From: Dan and Karen Thompson <dkthomps@yahoo.com>
Sent: Saturday, December 5, 2015 9:15 AM
To: Ravalli County Commissioners Office
Subject: Meadow Vapor Comments
Attachments: Scoping comments.docx; Scoping_road_data_rcorua.xlsx.pdf; Travel Plan Map.pdf

Ravalli County Off Road User Association

This letter constitutes the Scoping comments from the Ravalli County Off Road User Association (RCORUA) for the proposed Meadow Vapor project as outlined in your letter dated November 17, 2015. RCORUA is a group of about 350 citizens from Ravalli County who advocate for active management of Forest lands to improve the resilience of our forests to wildfire and insect infestations, and to improve all forms of recreational experiences on those lands. RCORUA members often pursue their recreational interests in the proposed project area and will be directly affected by the outcome of this project. We respectfully request that these comments be included as part of the administrative record for the Meadow Vapor project and that RCORUA continue to be considered as an interested party as the project proceeds through the NEPA process.

**REYNOLDS-LICK CREEK AREA
TAKEN FROM THE FEIS FOR THE BNF TRAVEL PLAN**

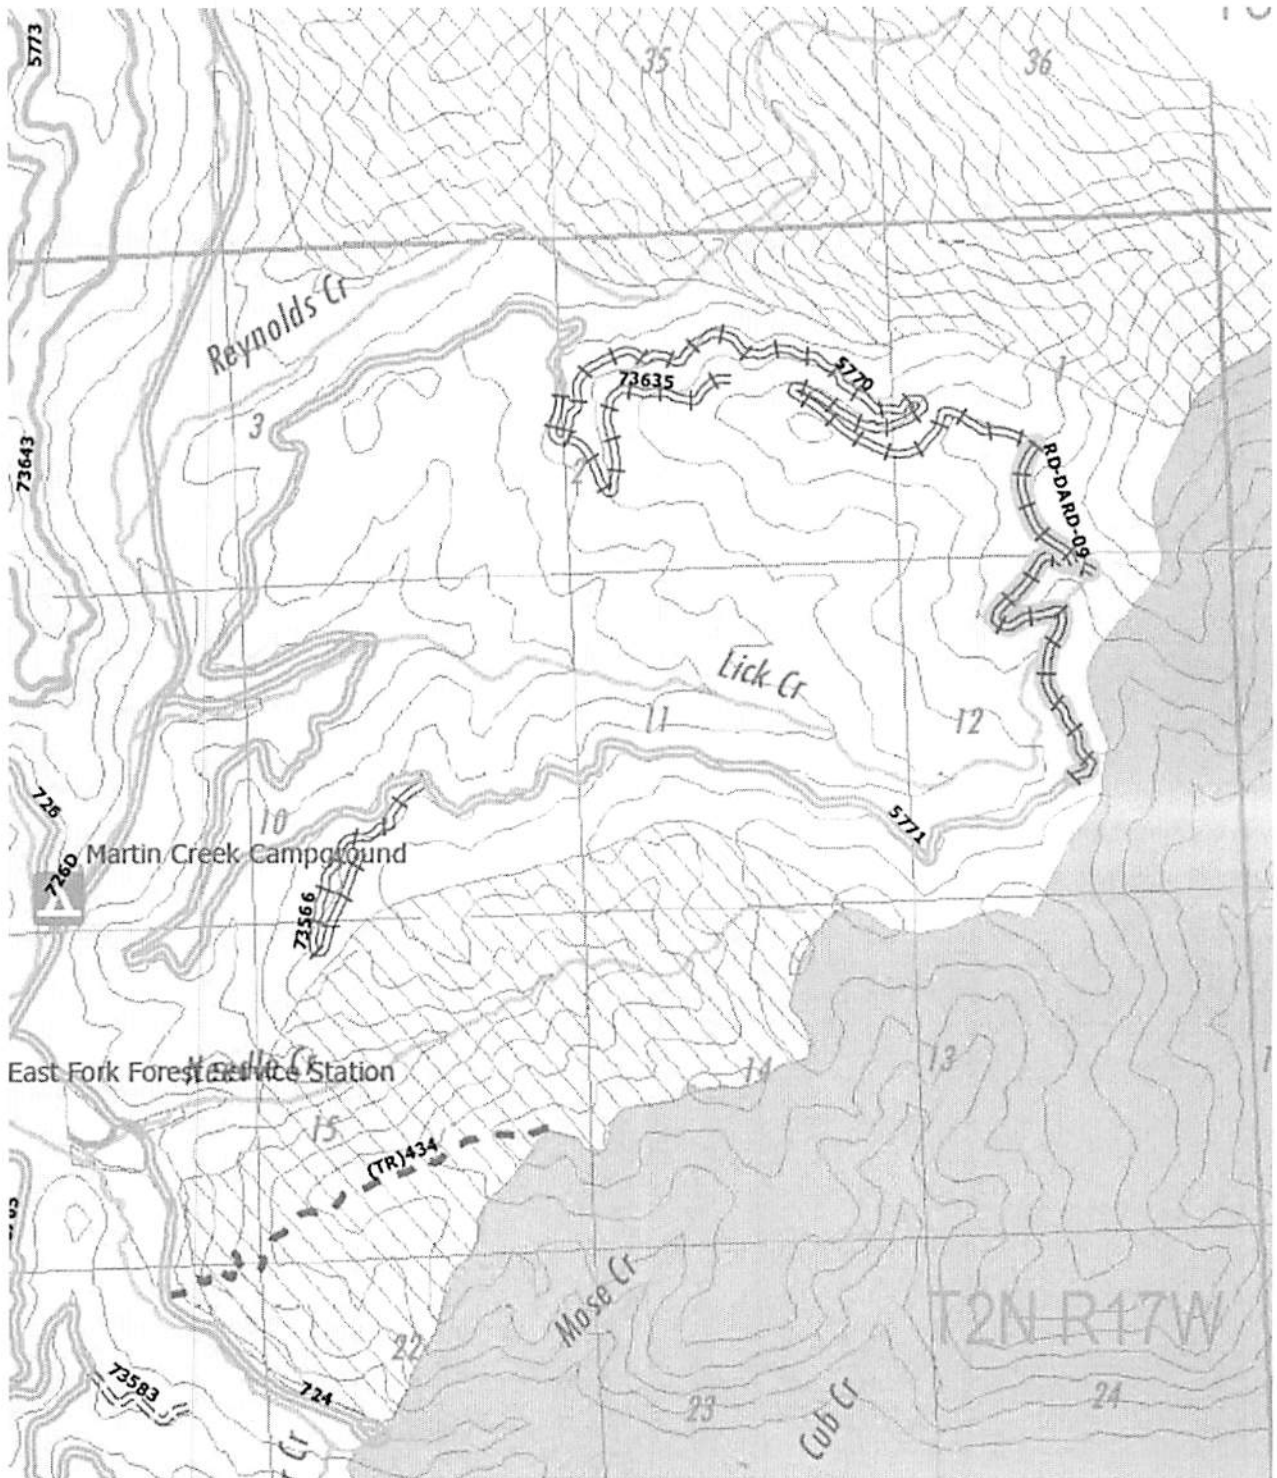
The BNF Travel Plan includes the designation of an ATV loop route in the Meadow and Lick Creek area. This designated route utilizes Roads 5770 and 5771 along with a new short connector trail to form a highly desirable and sustainable ATV route (see attached map). RCORUA strongly recommends that the completion of this route be included as part of the Meadow Vapor project. The elements of this recommendation would include:

- Decommissioning the appropriate segment of Rd 5770, designating it as a system trail, and reconstructing it as an ATV trail;
- Decommissioning the appropriate segment of Rd 5771, designating it as a system trail, and reconstructing it as an ATV trail;
- Construction of a short connector ATV trail (RD-DARD-09 on the attached map) between the ends of Rds 5770 and 5771.
